**Subject:** RE: Project Update on River Point and Concurrence on Importing Fill

Subject: Project Update on River Point and Concurrence on Importing Fill

# Figure 1 - Vinton Quarry and Known Spill Cases

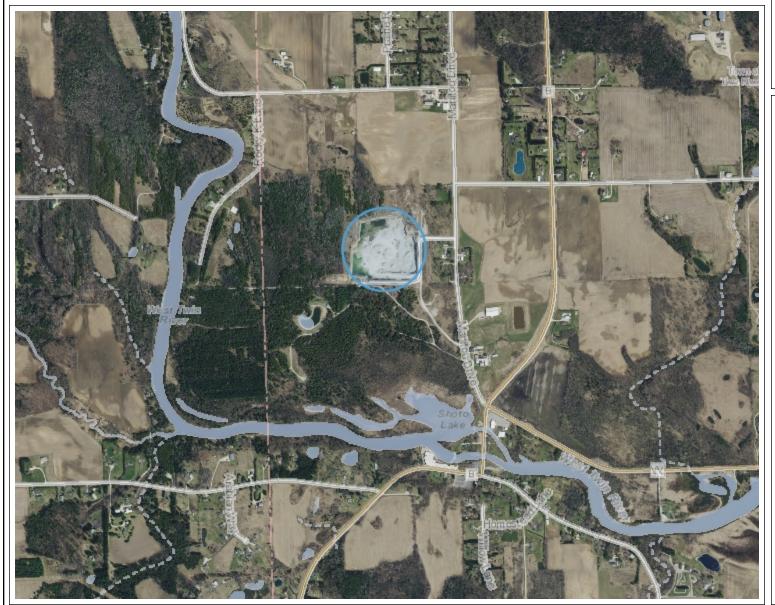
Vinton will need to import ~6,500 cubic yards of soil to bring the future roadway to rough grade. They are proposing to source the imported fill from their commercial quarry located at 1301–1377 Kristy-Bob Ln in Two Rivers, WI 54241. I understand this is in-place quarry overburden...NOT stockpiled material sourced from another project. As illustrated on the attached, there are no known spills/releases within a mile of the quarry.

Therefore, as we've done previously for importing fill to the ROW at River Point, given the origin of the proposed soil, we would propose not sampling this material prior to importing for use as fill. <u>Just wanted</u> to confirm if you concur with this approach.

This approach seems consistent with what you have been doing for importing material to the River Point District.
